Project Name, If Applicable: Aviles Residence

Project Street Address: 87 Kensington Rd, Bronxville NY 10708

PLAN REVIEW COMMENTS

APPLICATION NUMBER: ALT 074-24
DATE RECEIVED: March 6, 2024
LOCATION: 87 Kensington Road
SBL: 23./6/22
APPLICANT NAME: Nick Faustini
DESCRIPTION OF WORK : New driveway addition at front yard.

PROPOSED PLOT PLAN

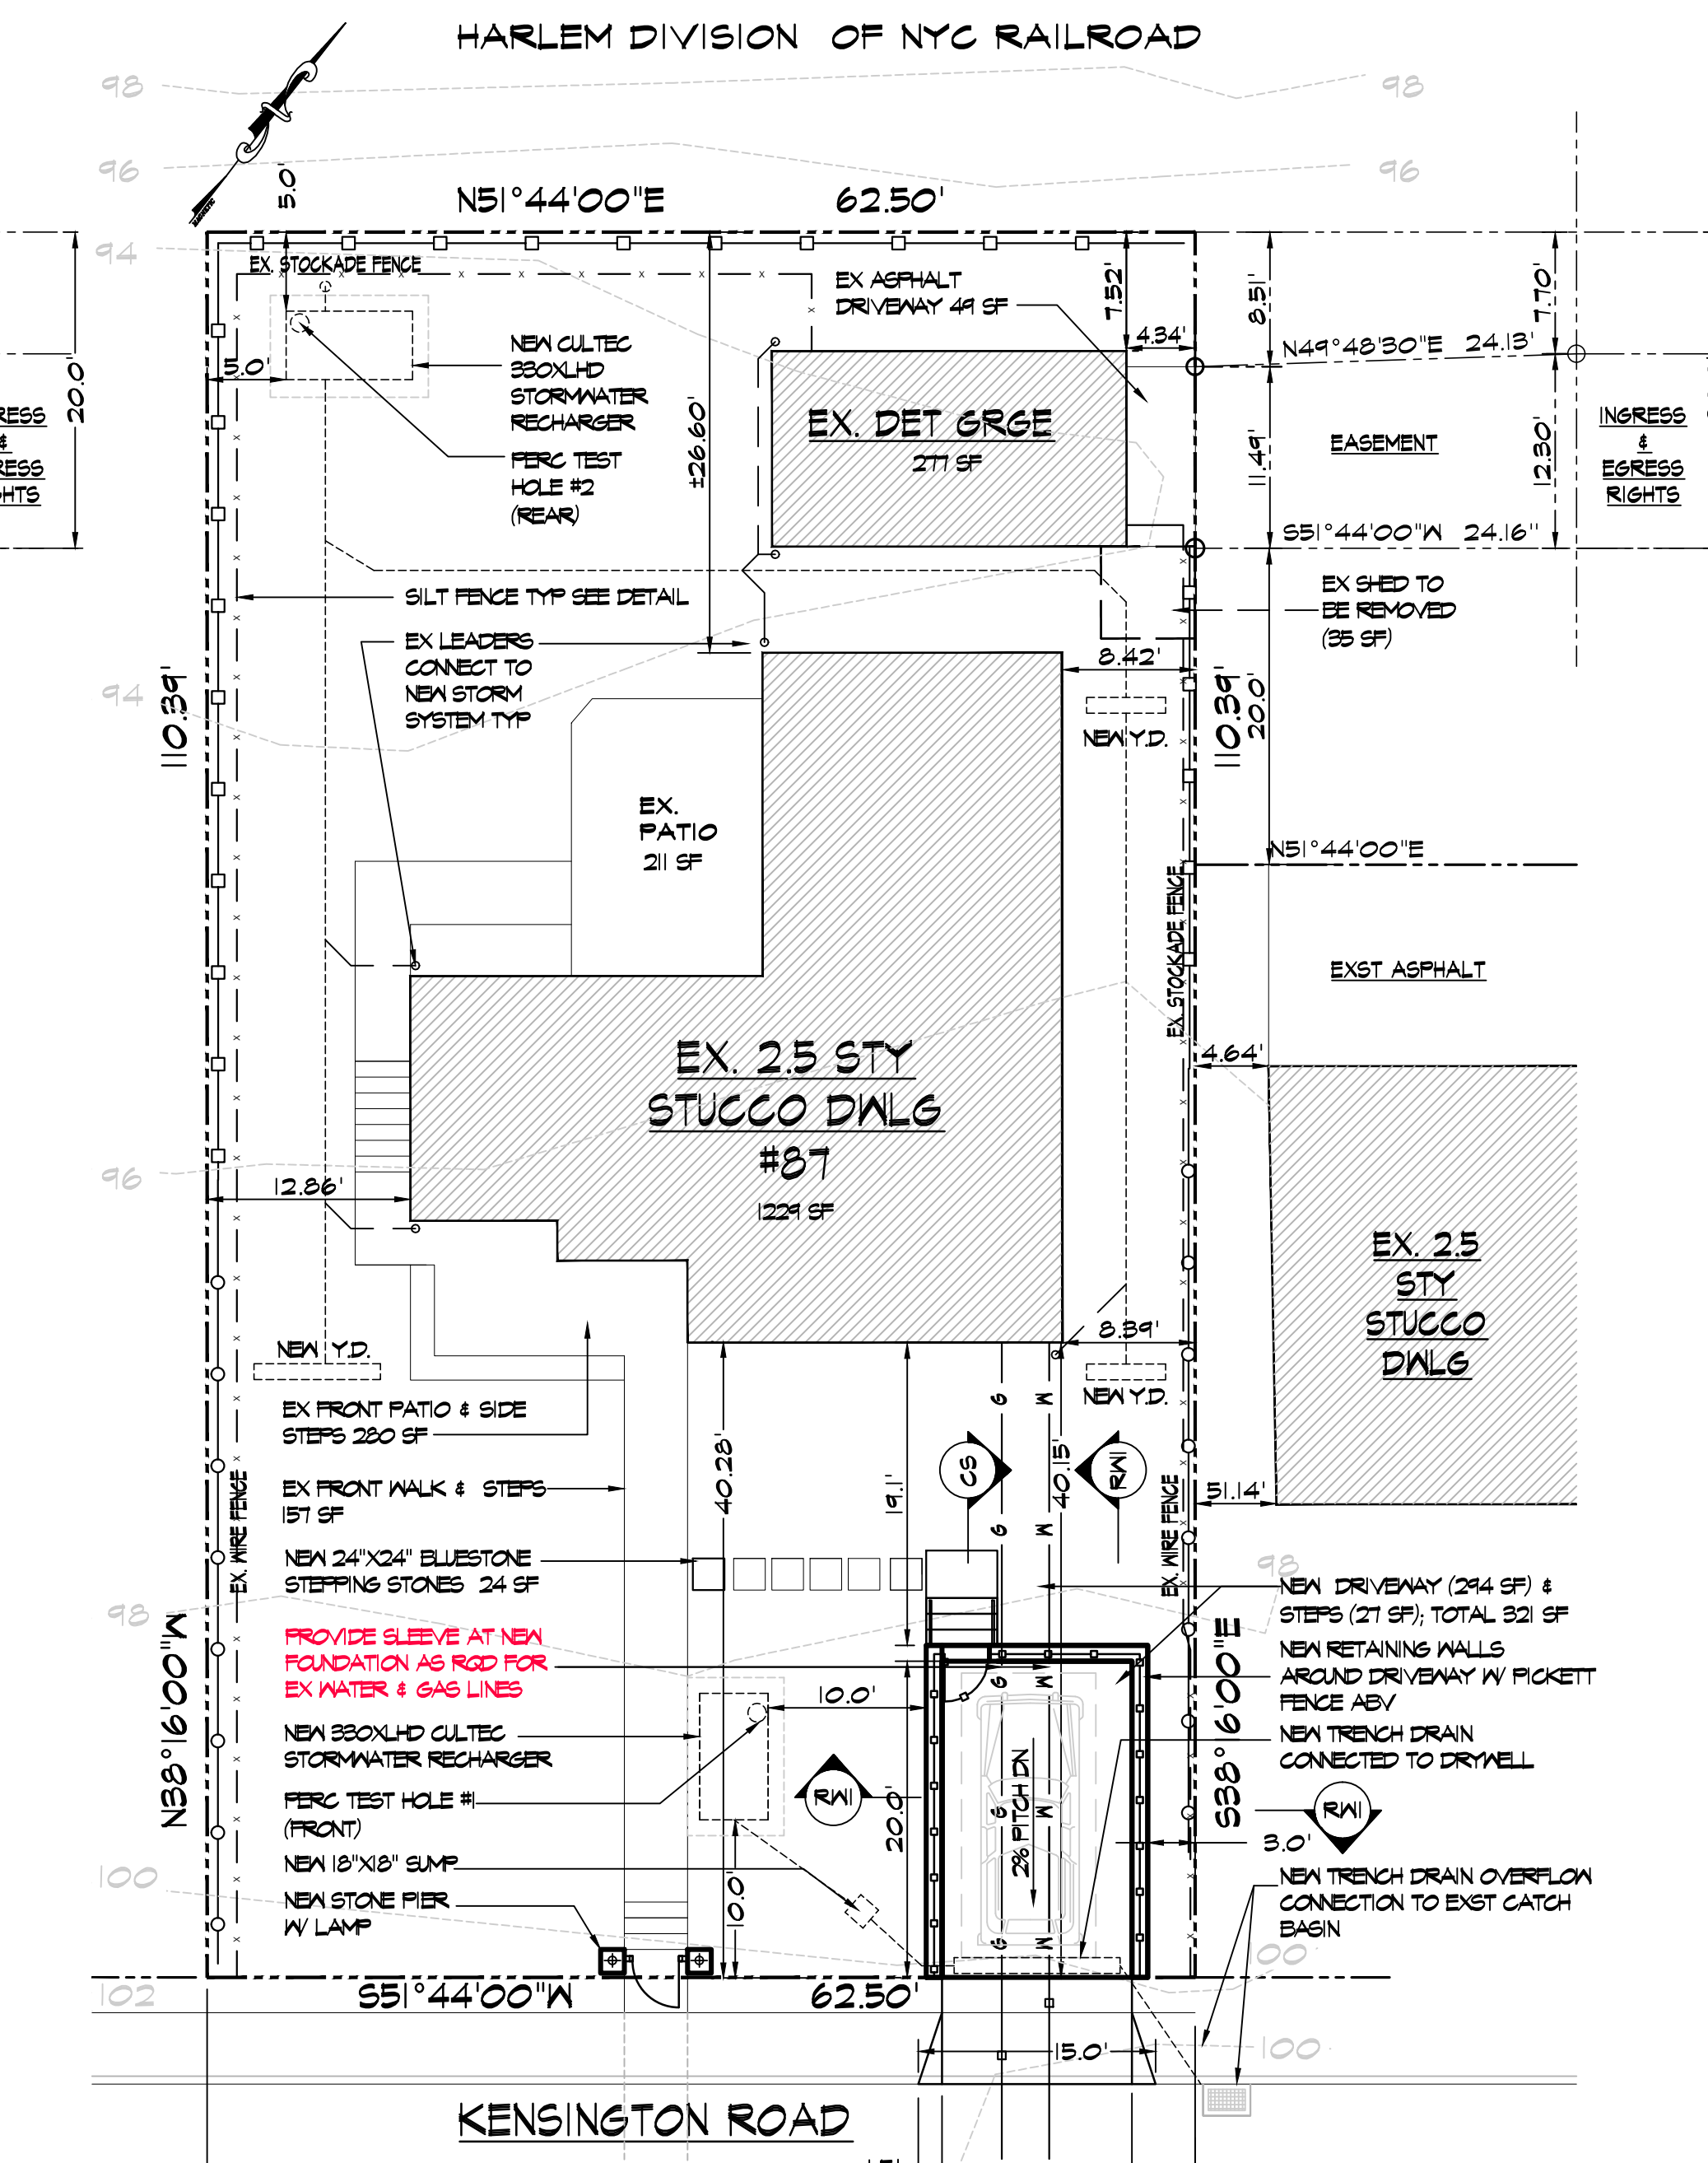
- 1) As per 310-11J - ..."No parking space shall be located in any front yard".. - proposed new parking space requires a variance - installation of a parking space in the front yard.
- 2) As per 310- 22 D Parking in front yards prohibited in residential districts. ...not permitted within front yard..In addition, all driveways shall be setback at least 3 feet from any side yard lot line... Variance is required for parking in front yard and for less than 3 feet to the side yard lot line.
- 3) As per 310-11D 4 (a) - fence and walls - maximum combined height - 6-1/2' proposed 7'. variance required - 6" for fence wall height.
- 4) 310-11D 4(a) - fence and walls - required to be not more than 1/2 solid – stone retaining wall requires a variance.

- 1) Complete drainage plan required to be submitted by NY State Licensed Engineer.
\$1000.00 fee required for village consulting engineer review.
- 2) All drywells required to be a minimum 10' from any lot line, building.
- 3) Tie into public storm sewer system is not allowed.

- (1) The proposed driveway has been relocated 3ft away from the north property line to allow for a planter area adjacent to the driveway. The revision also includes a slight reduction in impervious surfaces and elimination of the previously cited area variance for proximity of the new driveway to side property line.*
- (2) The submission has been supplemented to include an exterior rendering of the proposed parking area*
- (3) The submission has been supplemented to include front yard street views of the structures north & south of the subject property with photo and tabular analysis of off-street parking*
- (4) The submission has been supplemented with letters of support from several neighbors in the area.*
